# Changes to ANSI/IEEE Std 802.3-2000, Clause 30

EDITORIAL NOTES - This supplement is based on the current edition of IEEE Std 802.3, 2000 as modified by Draft 3.1 of IEEE P802.3ae, 10Gb/s Ethernet. The editing instructions define how to merge the material contained here into this base document set to form the new comprehensive standard as created by the addition of IEEE P802.3af.

Draft 1.0, July 2001

**Figure 30-3—Entity relationship diagram**

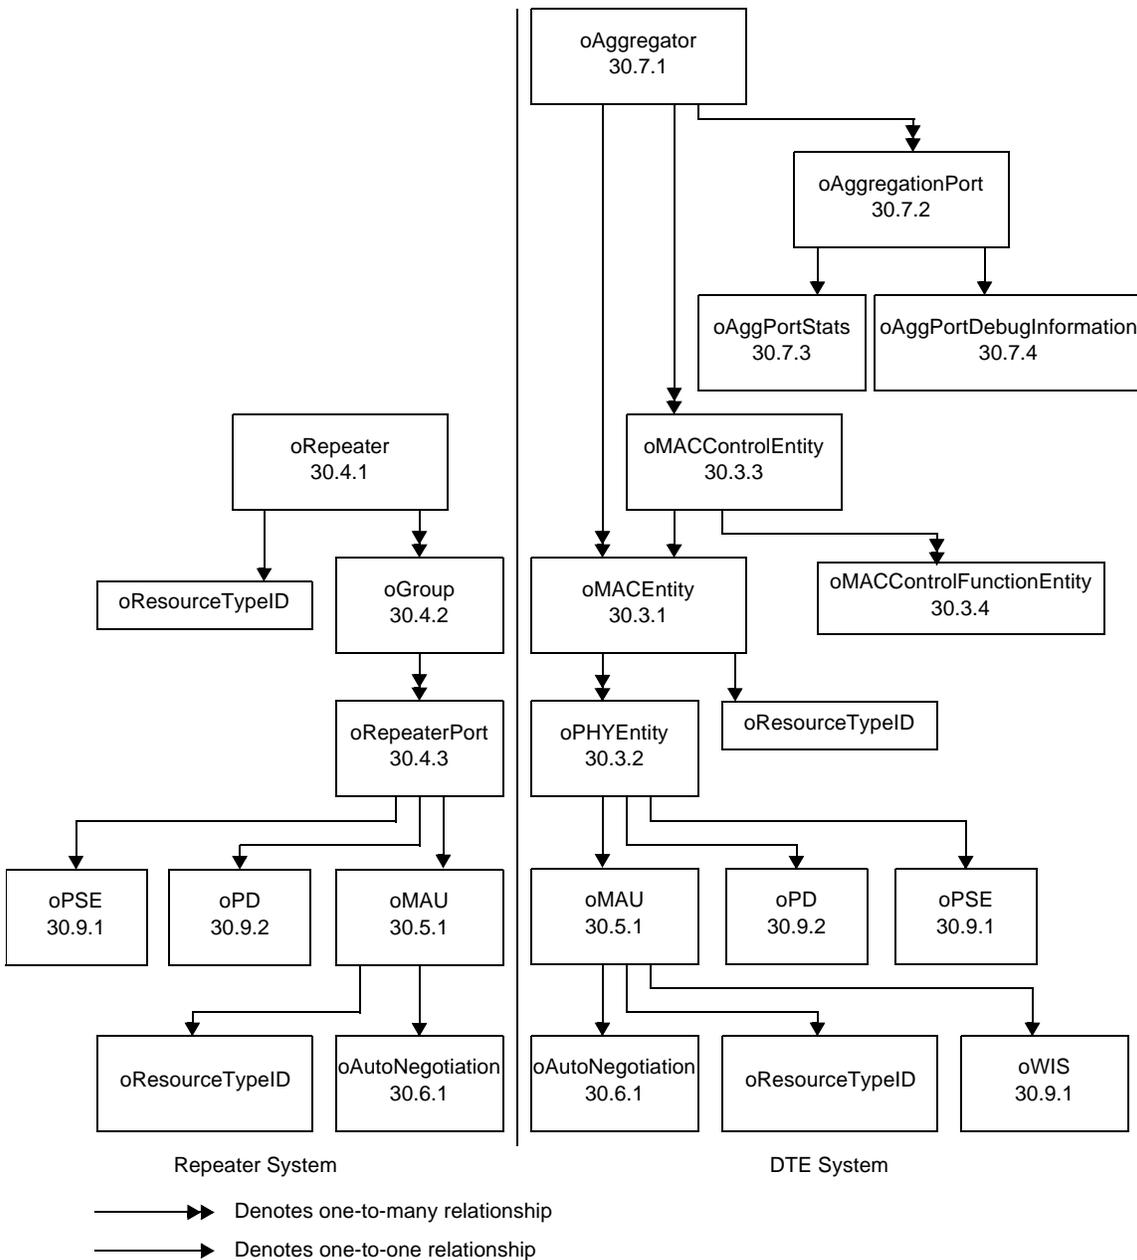
Change the Figure 30-3 as follows:

**Comments:**  
 1 It is assumed that it is permissible to allow a Repeater to be a PD even though that is actually Repeater Power via MDI rather than DTE Power via the MDI.
